S4.55 APPLICATION REPORT 95 GURNEY CRESCENT SEAFORTH FEBRUARY 2021

1.0 INTRODUCTION

This report is submitted to Northern Beaches Council in support of a S4.55 Application for 95 Gurney Crescent, Seaforth. The Statement of Modifications for the requested amendments is covered below.

LEVEL 3 LIVING

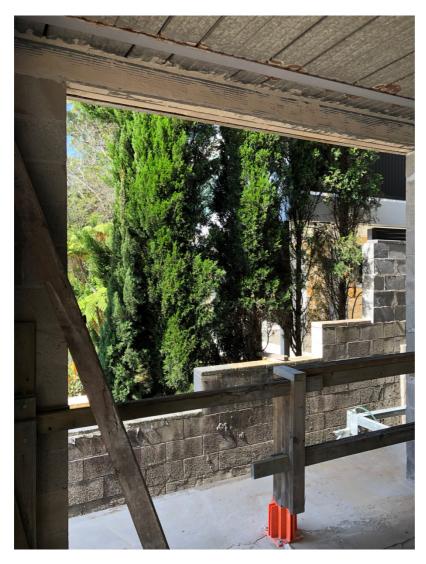
Demonstration of privacy screen impact on Owner with no benefit to neighbour
